Re: Ecogy Kitchawan Community Solar Farm LLC Updated Landscaping Plan and Access Road Design

Project Name:
KITCHAWAN
2670.3 KW-DC PV SYSTEM
GROUND MOUNT

SITE PLAN

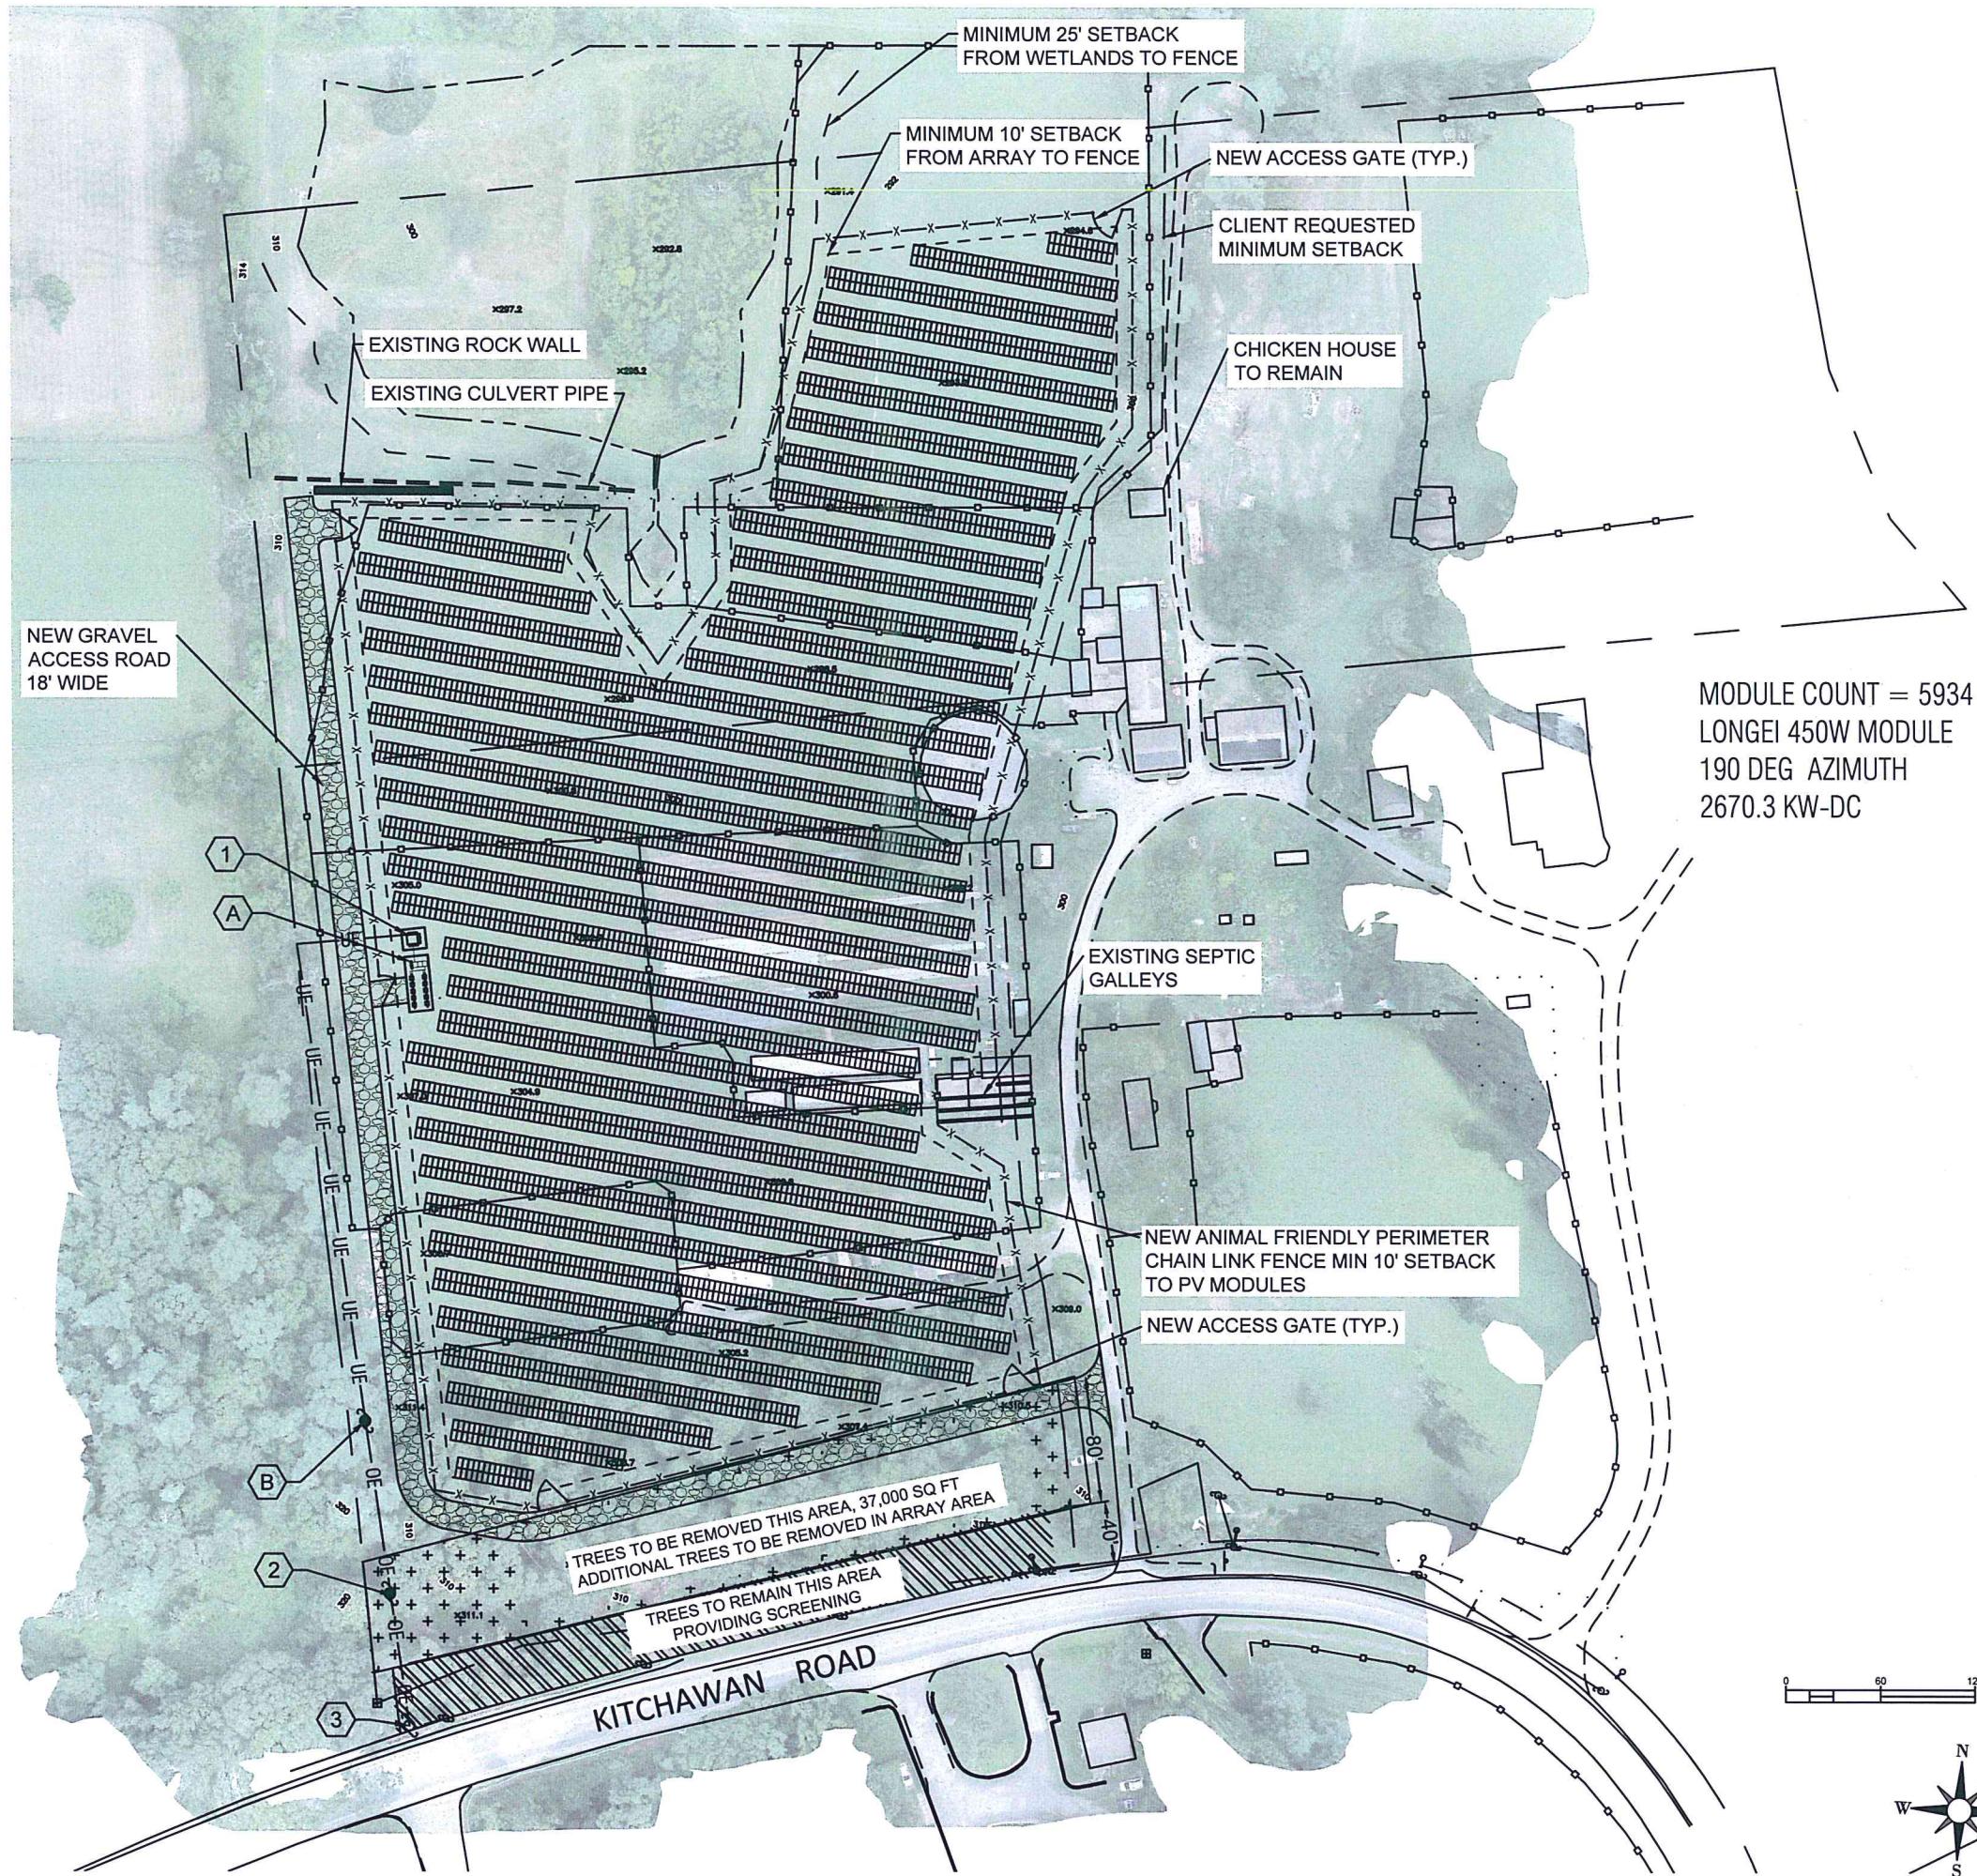
In addition to the changes to the landscaping plan, Ecogy has also updated the design of the site access road. Ecogy had previously planned for the access road to use an additional driveway onto Kitchawan Road (NYS Route 134). However, after consultation with the Department of Transportation (DOT), we were informed that an additional driveway onto the state road would not be permitted by the DOT due to safety concerns, as the property already has two driveways. Due to this, Ecogy has updated the site plans to connect the solar access road to an existing driveway. Changing the access road design has the added benefit of increasing screening along Kitchawan Road since there will no longer be a line of sight along the new access road towards the solar arrays. The updated site plan is included in this submission package for the Board's review.
